Our Ref LJ8827/L1902 :sge

## **LAUDERDALE QUAY DIIS – COASTAL PROCESSES AND CLIMATE CHANGE SUBMISSION**

The purpose of this document is to provide detailed responses to the submission made by Mr Daniel Ray of Aquatic Science on behalf of Save Ralphs Bay Inc to the Resource Planning and Development Commission in respect to proposed development of Lauderdale Quay.

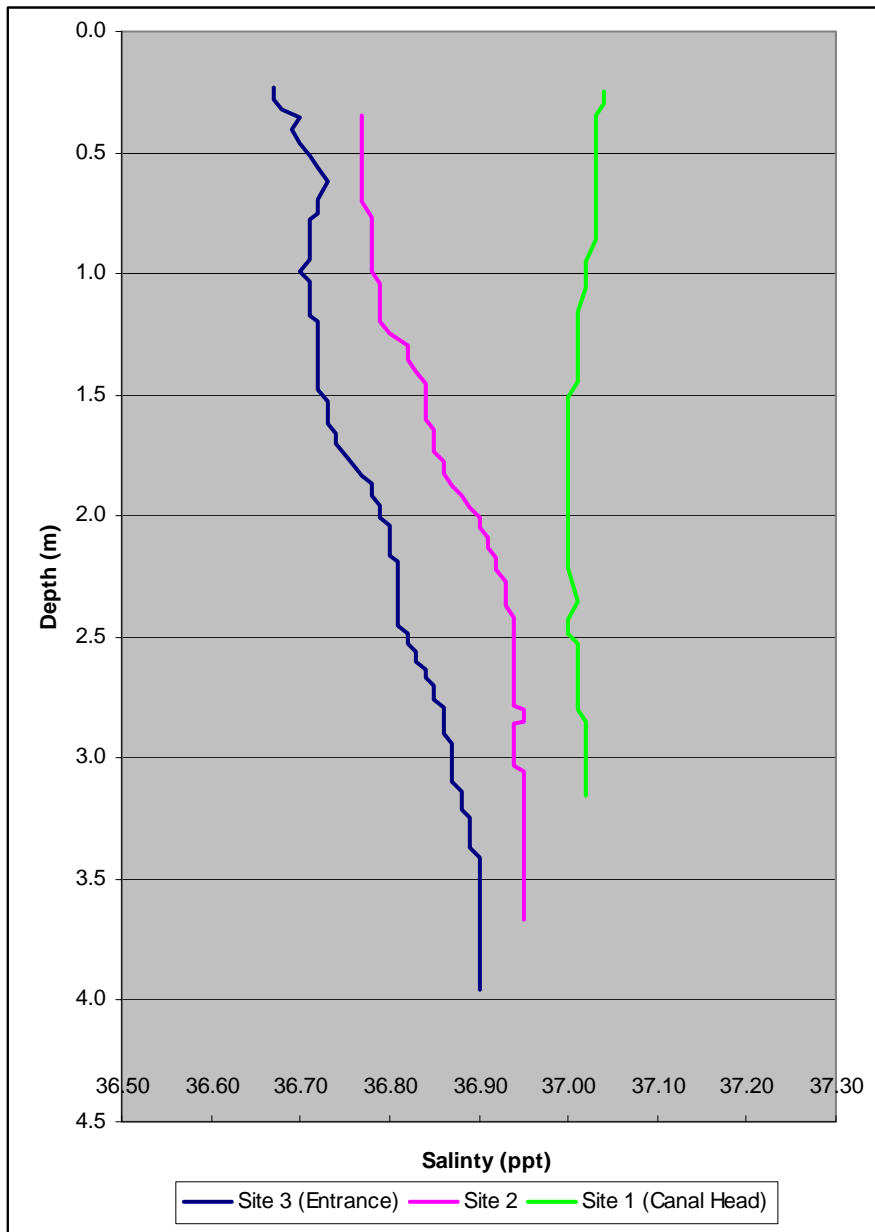
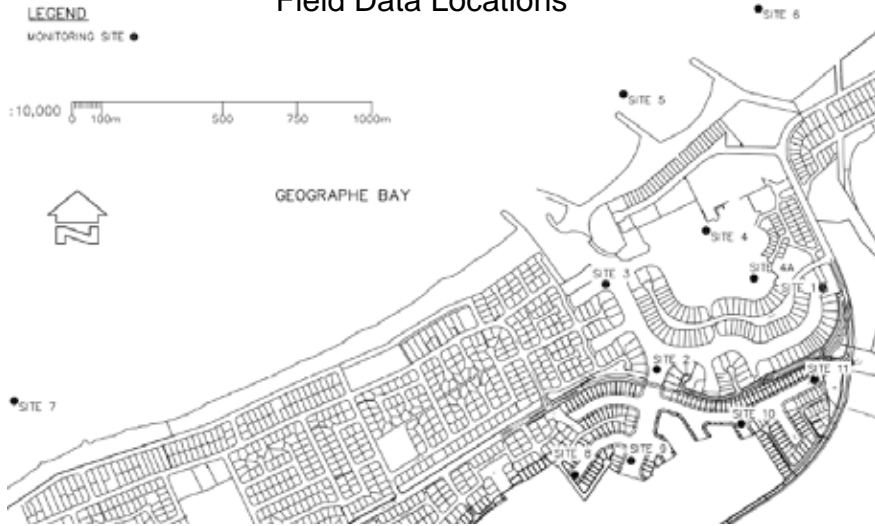
Another example is Lake Macquarie in NSW where stratification is caused by cooling water discharges from a power station. Attached Figure 2 compares measured and modelled temperature profiles that demonstrate good stratification agreement between the Delft3D model and recorded data. Figure 3 presents a time-series plot of measured and modelled (Delft3D) water temperature conditions at Port Geographe over a period of a few weeks. Considering the uncertainty in the input solar radiation data, the agreement between modelled and measured water temperature over time is very good.

# Field Data Locations

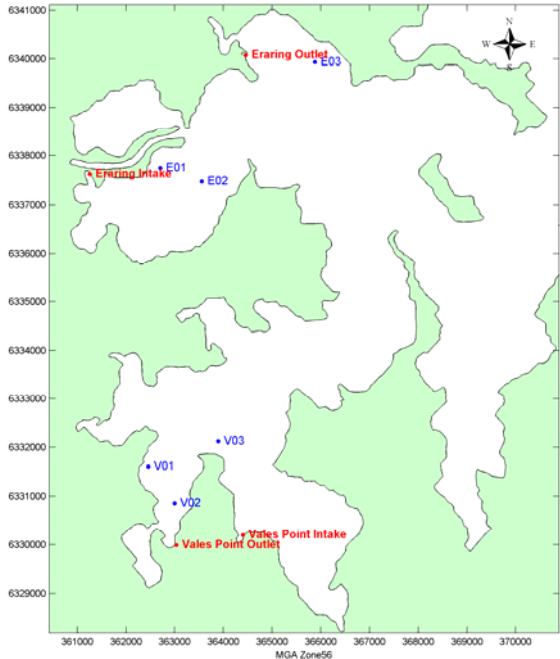
The modelling technique adopted in the investigation made direct use of the measured data; contrary to the assertions within the submission prepared by Mr Ray. Salinity and temperature profiles from Location RB4 data were applied at the 3D model boundary and the existing case verified at the other 3 locations (RB3 to RB1). This showed that the model replicates the existing stratification within Ralphs Bay extremely well. Using this verified model setup the developed case was then simulated and no substantial stratification was observed within the proposed canal development.
